**EPA Superfund
Explanation of Significant Difference
for the Record of Decision:**

**Cornhusker Army Ammunition Plant
Hall County, NE
2/7/1997**

CORNHUSKER ARMY AMMUNITION PLANT (CHAAP) OPERABLE UNIT ONE

February 7, 1997

GENERAL AREA
PLOT PLAN

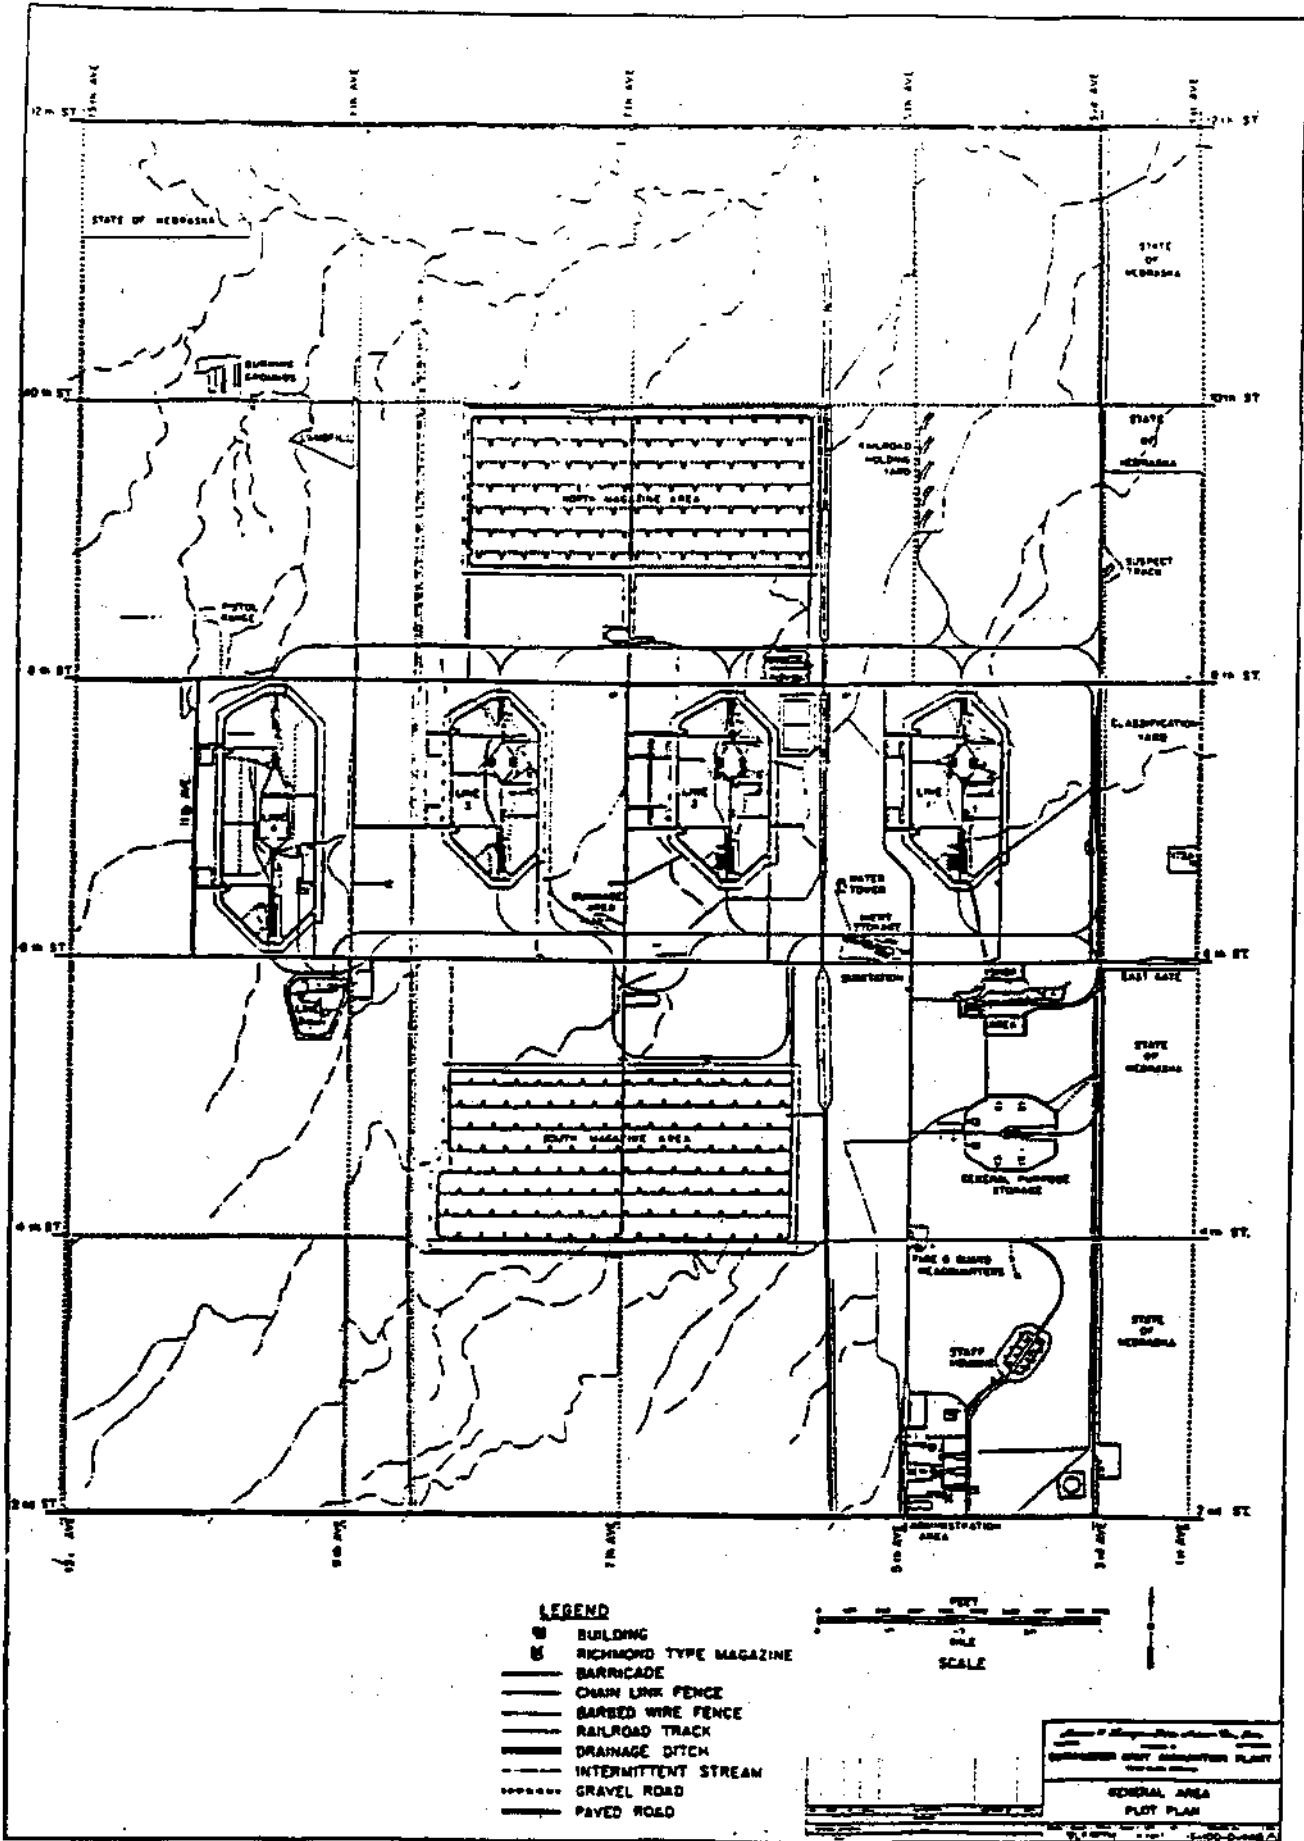
In June 1996, the U.S. Army presented a plan to discharge treated water from the proposed groundwater treatment facility at CHAAP to Silver Creek at a location near the northwest corner of CHAAP. Previously, the discharge point was to be the Platte River at a location approximately 14 pipeline miles from the groundwater treatment plant on CHAAP. The proposed discharge location was changed because the design flow rate for the discharge was reduced during design evaluations from approximately 11 cubic feet per second (5000 gallons per minute (gpm)) to approximately 5 cfs (2150 gallons per minute). An evaluation of the potential for increased flooding problems associated with the discharge to Silver Creek was prepared. The analysis determined if the discharge from the treatment plant stopped during periods of

Under the phased approach, the Army proposes to begin on-site extraction and treatment as soon as possible. The treated water would be discharged to an existing

drainage canal located on CHAAP. The water in the canal would discharge to Silver Creek after traveling through CHAAP for about two miles. This proposal differs significantly from the earlier Silver Creek discharge proposal in two ways:

1. The discharge flow is lower-only 1.7 cfs/750 gallons per minute. The initial period of lower flow would allow an opportunity to evaluate the modeled versus actual impacts from the discharge. This information would be used to evaluate the need to change discharge locations in the future. It will allow real time data to determine the capabilities of the Creek for any future off-post actions.

2. The revised model demonstrates the effects of 1.7 cfs discharge into the Eastern Drainage Canal. Under the most likely conditions, the model anticipates much of the water would infiltrate through the on-post canal bottom during transport to Silver Creek. Therefore the amount of water reaching Silver Creek would be even less than the amount of treated water discharged to the canal.

Under the OUI Record of Decision the discharge location is the Platte River. This would require the effluent to be piped thirteen and a half mile underground. Changing the discharge location to the Drainage Canal would require a maximum of a quarter mile of effluent pipeline. This change would save over 13 miles of underground pipeline, approximately four months of construction time and five to six million dollars. This figure does not include reduction in real estate acquisition procedures or maintenance costs, which will
